**TECHNICAL BULLETIN**

**Product :** Midilift SL

**Subject :** Midilift 3m ram installation method.

Pictorial representation of the structural changes.

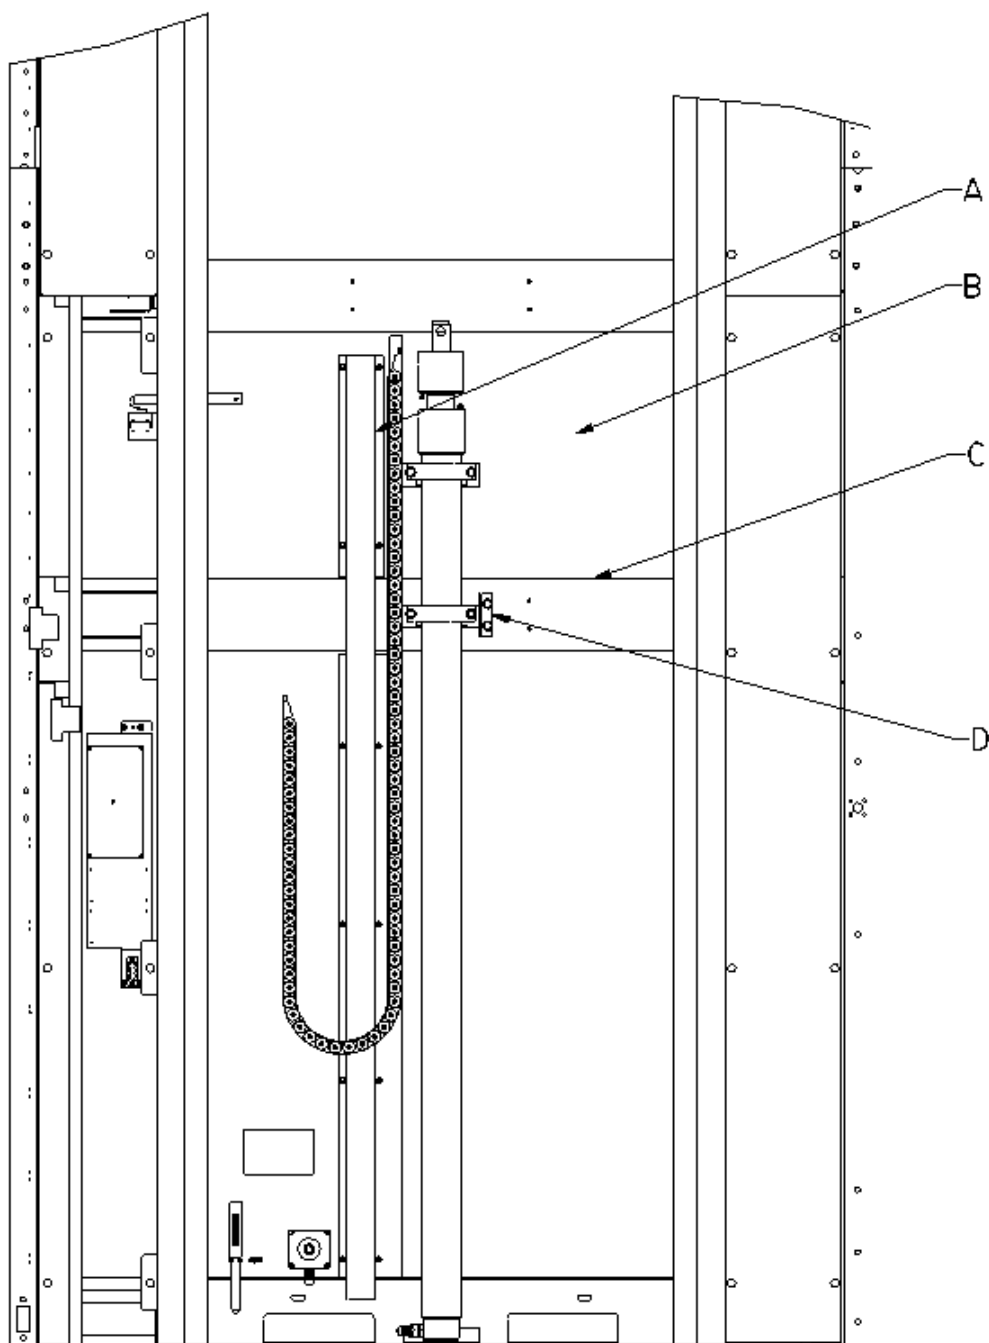
It has been recorded that on 2.5m to 3.0m three panel lifts, the ram clamp bracket that is used is prone to excessive flexing. This leads to the carriage control box fouling on the bracket during travel. Consequently, it is proposed that an additional horizontal member be added to allow an alternative design ram clamp bracket to be used. This will eliminate the flexing.

The installation of the structure will, for the main part, remain largely unchanged. However the following points, which refer to the diagram on page two, are different for lifts of a travel 2501 – 3000 mm travel and utilising the three panel structure arrangement.

- A. Trailing cable cover that has been designed to fit over the additional horizontal member, this is secured in the usual manner with self drill screws.
- B. Factory cut panel that is inserted between the new horizontal member and the existing guide side horizontal member.
- C. Additional horizontal member that is to be installed above the first two panels on the guide side. It is to be secured by way of four M8x20 screws and four M8 washers located through the corner uprights.
- D. New design ram clamp bracket that is to be attached to the additional horizontal member by way of four M8x20 screws and four M8 washers. The ram is then secured by way of the clamp brackets and fixings by way of four M8x20 screws and four M8 washers.
